# SERVICE BULLETIN

**Service Bulletin No. / Date:** SB TMG 601-1008 P1, Initial Issue / January 20, 2016

**Subject:** Turbocharger hose replacement

**Type affected:** All Cessna C172 (Reims F172) with TAE 125-02-99 and TAE 125-02-114

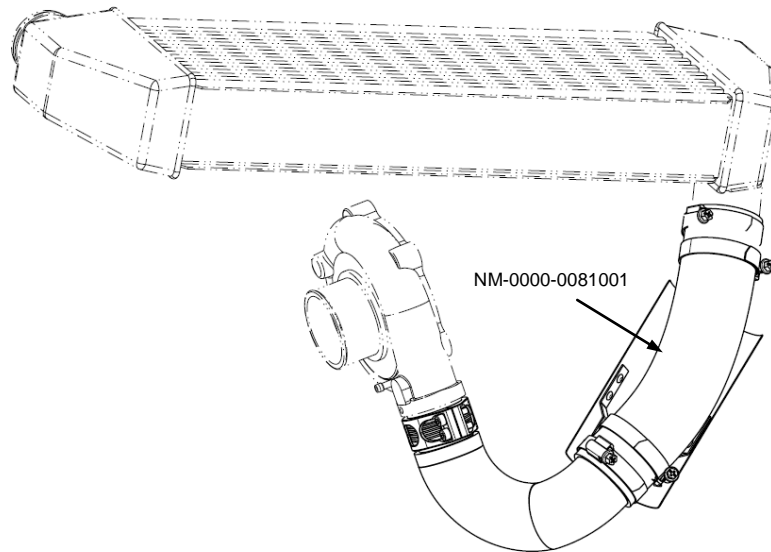
**Action:** Due to field failures the turbocharger hose NM-0000-0081001 should be replaced by an improved version at a maximum lifetime of 900 flight hours.

- If removed, install the turbo pipe and fix via turbocharger clamp. Align the turbo pipe to the intercooler port and secure the turbocharger clamp.
- Shorten the air hose (item 1.1) as required.
- Attach the air hose to the turbocharger pipe and to the intercooler port.
- Secure the hose with two hose clamps (item 1.2) on each side. Fasten also the heat protection sheet.
